Sydney Grammar School Weigall Sports Complex (SSD-10421)

Response to Submissions

State Significant Development Application

23 April 2021 | 19049

Figure 2 – View 01: Unit 3310/12 Neild Avenue (Source: Urbis)

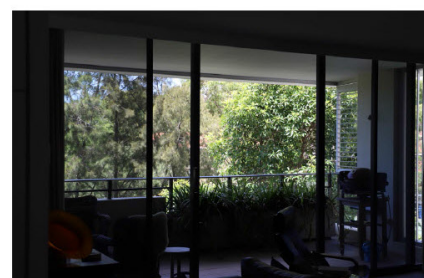
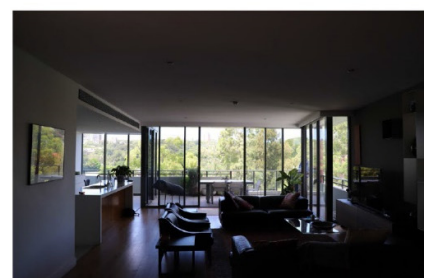
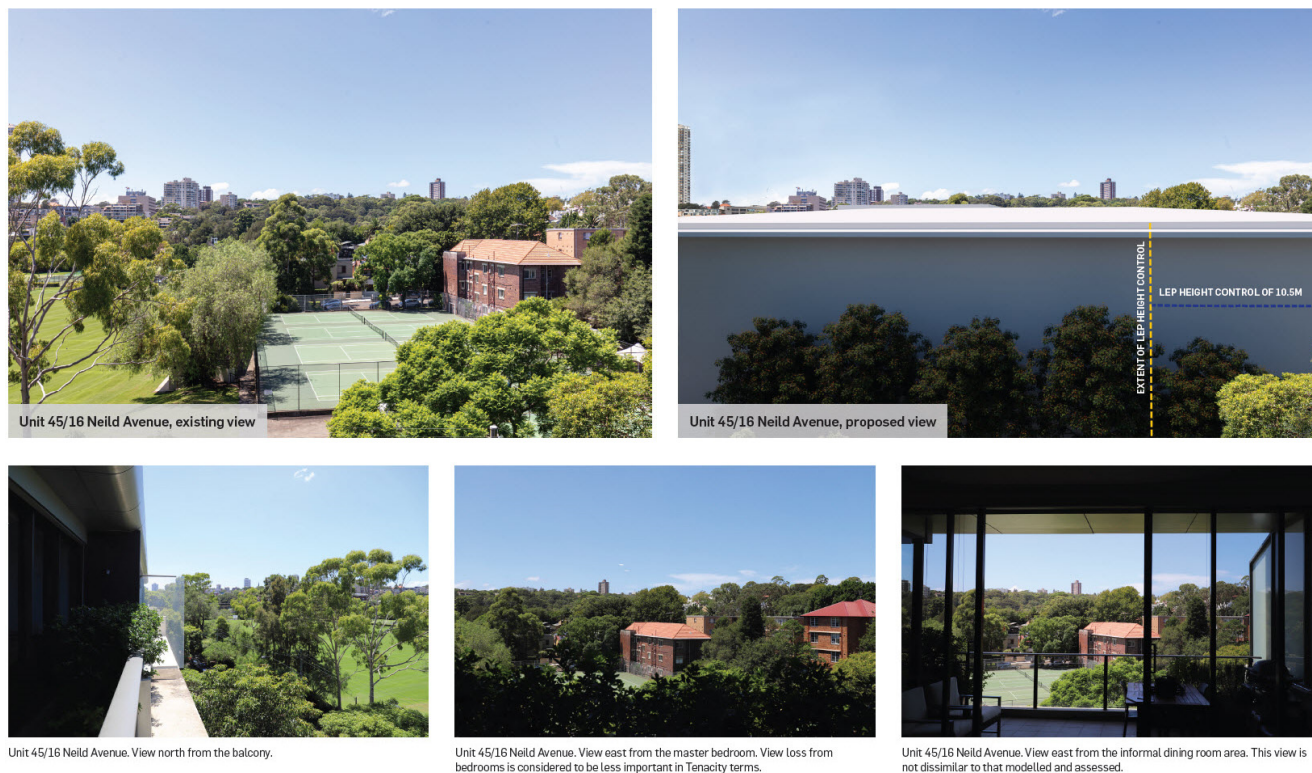
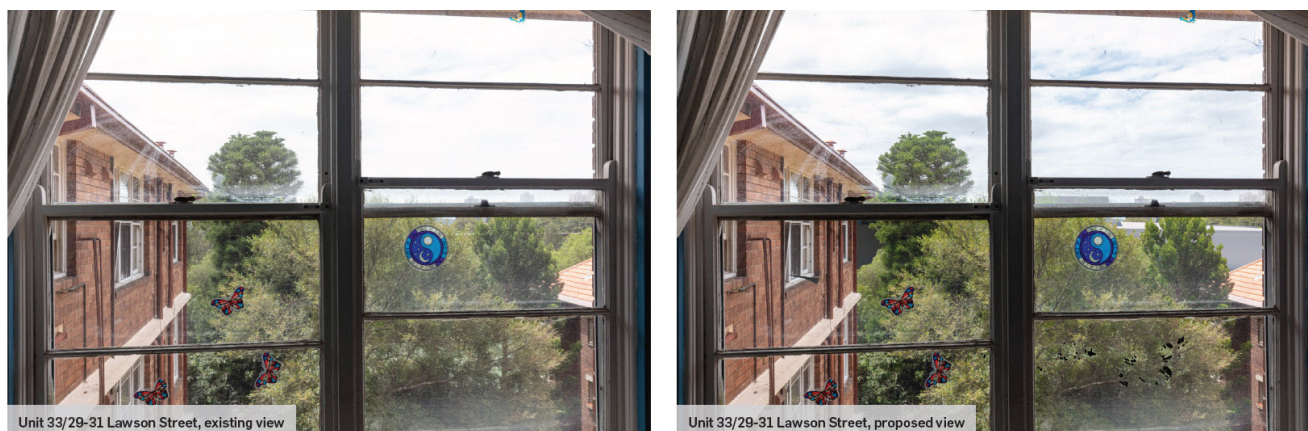
The Department concurs with Woollahra Municipal Council's (Council) concerns with respect to view impact. Given the significant and details [sic] concerns raised by Council, you are requested to explore opportunities to reduce the building height to provide view sharing for neighbouring sites, especially the properties to the south and west of the site

The Addendum Visual Impact Assessment by Urbis (**RtS Appendix E**) considers the private view impacts for the listed dwellings at 29-33 Lawson Street and 12 and 16 Neild Avenue (see **Figure 1**). **Figures 2 to 7** show the private view photomontages relied on by Urbis and the view impact conclusions noting the following as relevant:

Using the Tenacity view sharing principle, Urbis concludes that the view impact of the proposed Weigall Sports Complex is acceptable, as set out in their conclusion which is copied below:

Figure 9 – ADG Visual Privacy: 29-33 Lawson Street (Source: AJ+C)

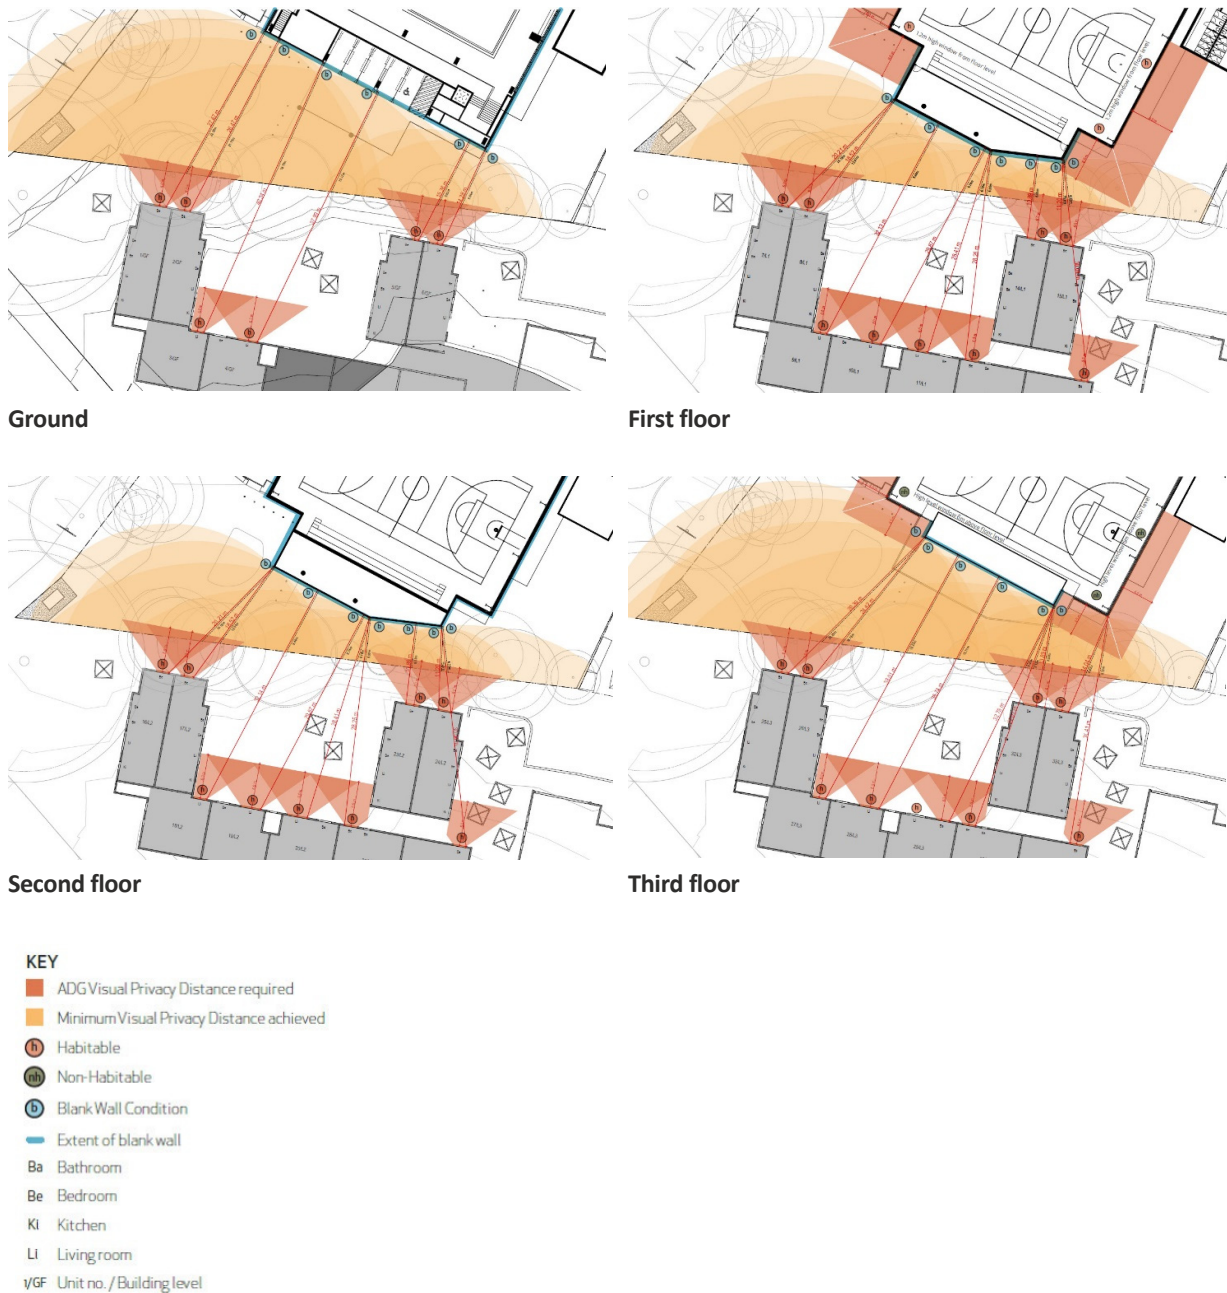
The EIS states that building separation criteria within the Apartment Design Guide (ADG) under State Environmental Planning Policy No 65 - Design Quality of Residential Apartment Development has been applied for the proposed development with respect to existing resident flat buildings (RFB) to the south (8 Vialoux Avenue and 25-33 Lawson Street). In this regard, the Department requires you to provide the following information:

- a) details to demonstrate how the proposed development addresses the visual privacy requirements under ADG with respect to the adjoining RFB to the south. A detailed table of compliance with the separation distances should be included for each of the dwelling units/rooms fronting the proposed development.*
- b) hourly shadow diagrams (both elevation and plan view and a schedule with the unit numbers) to demonstrate the total number of hours the dwelling units located along the southern boundary would receive sunlight between 9am – 3pm during winter solstice.*

The RtS Design Report by AJ+C (**RtS Appendix C**) includes detailed plans and tables showing the ADG required and proposed setbacks/building separations for each dwelling to the south of the site. The analysis shows that:

- **29-33 Lawson Street:** The proposal fully complies with the ADG building separation distances at all levels (see **Figure 8**)
- **8 Vialoux Avenue:** The proposal fully complies with the ADG building separation distances at apartment Levels 1 and 2 but there is an area of non-compliance for two habitable windows at the Ground Floor of the apartment building (see **Figure 9**) where the ADG requires a separation of 12m between habitable windows (6m+6m) but 10.23m is proposed. This minor departure is reasonable for the following reasons:

Figure 13 – 3D height plane: View from the South West (WLEP 2014) (Source: AJ+C)

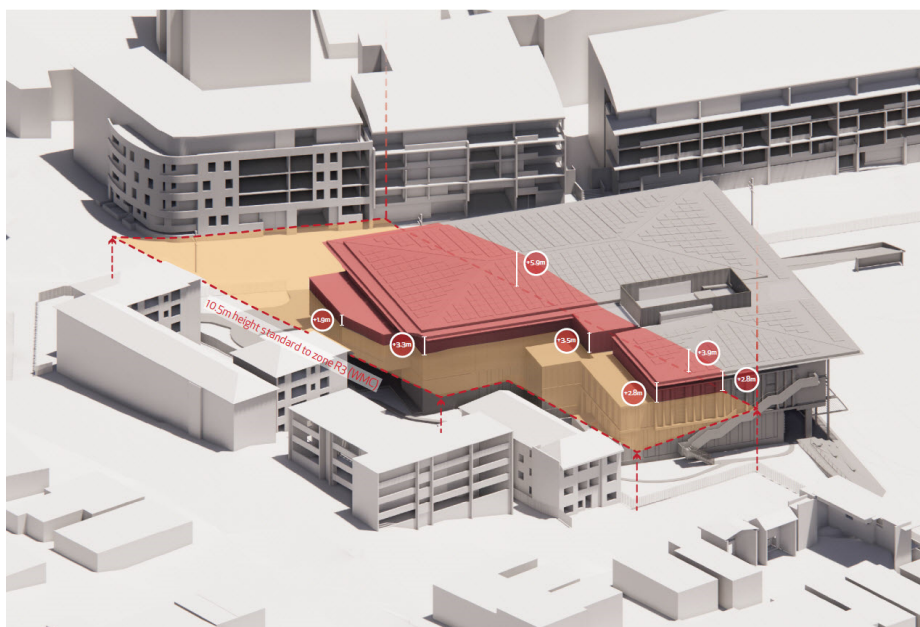
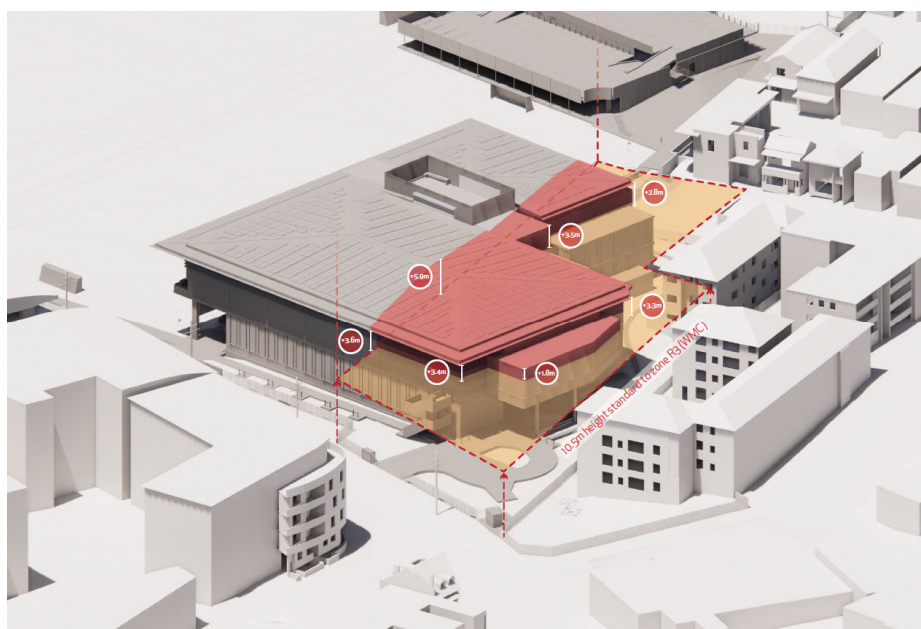
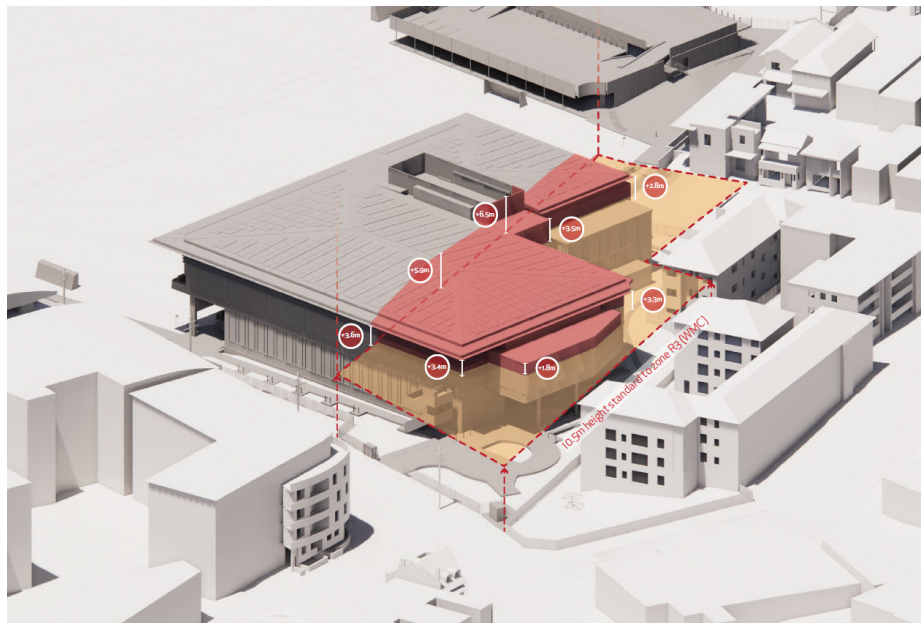
6. 3D height plan diagram

The Department requires you to prepare and submit a 3D height plan diagram showing the proposed buildings with an overlay of the height plane showing the maximum permissible building height line for the site (as stipulated by the WLEP), where applicable.

As illustrated by **Figure 11**, WLEP 2014 prescribes a 10.5m height standard over part of the SSDA site (being land in Zone R3 which comprises the existing tennis court site). The RtS Design Report by AJ+C (**RtS Appendix C**) includes 3D height plan diagrams that overlay the 10.5m height standard as follows:

- Building 1 as originally submitted and proposing a maximum height of 17m in the Zone R3 land (up to 6.5m above the 10.5m height standard)
- Building 1 with the amended roof plant room and proposing a maximum height of 16.4m in the Zone R3 land (up to 5.9m above the 10.5m height standard).

Figures 12 and 13 compare the original and RtS height plan diagrams and show that the taller elements in proposed Building 1 are located at the northern edge of the Zone R3 land, well away from residential land to the south. This minimises the shadowing and visual effects of height.

Figure 18 – Addendum Alma Street signage (Source: ptc)

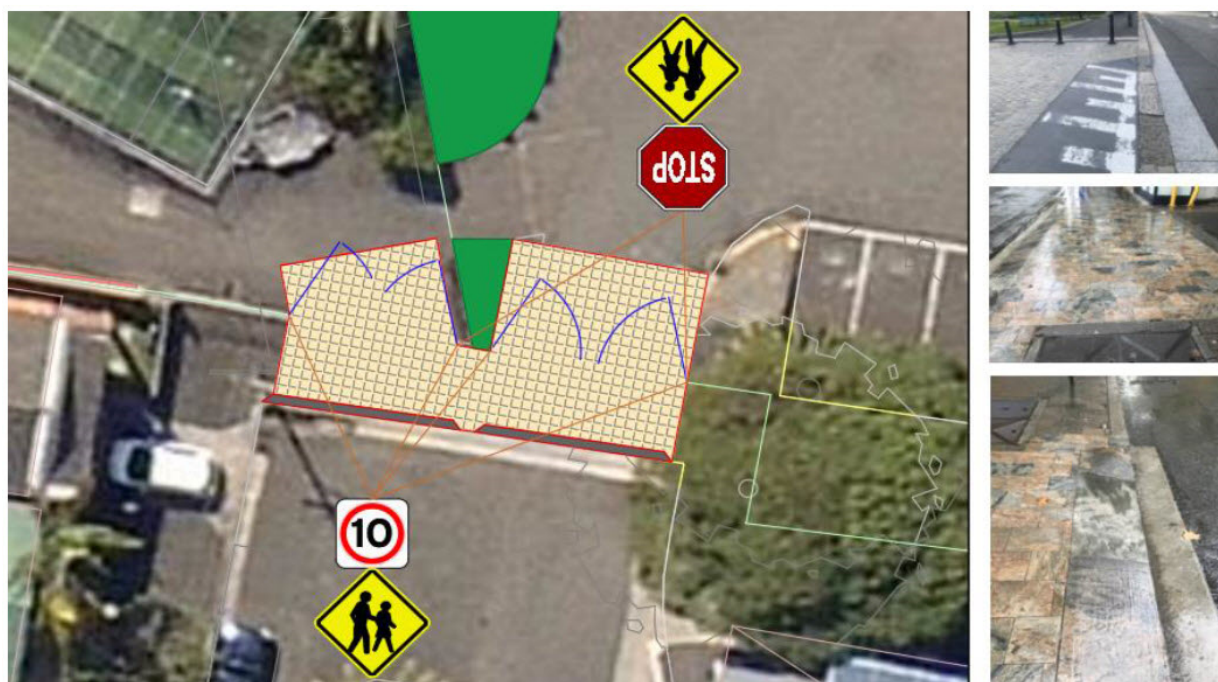
I have read the letter from P+I dated 8th February 2021, and while the use of Stop or Give Way signs is supported, it is not recommended to provide traffic lights in any form. This can be done when entirely within a private property, but there is no way of extending this into the public roads (including the footpath at the end of Alma Street) without becoming an official signal installation.

What would be useful is if there is a civil design of their driveway (perhaps based on my concept from last year) that we can check, mark up and send back. The same applies to our driveway when those drawings are ready.

The recommended signage is illustrated on **Figure 18** below and the relevant recommendations of ptc have been added to the Section 5.0 - Final Mitigation Measures.

- Install new Pedestrians sign (W6-1) on each side of both driveways, Stop signs (r1-1) on left-hand side of each driveway upon exiting the driveways and a 10km/h speed limit sign on both gates upon approaching from Alma Street
- Remove the existing 'dead slow' signs, as they are not recognised road signs
- Continue to work with the adjoining owner of the former White City site to ensure coordination of the driveway design.
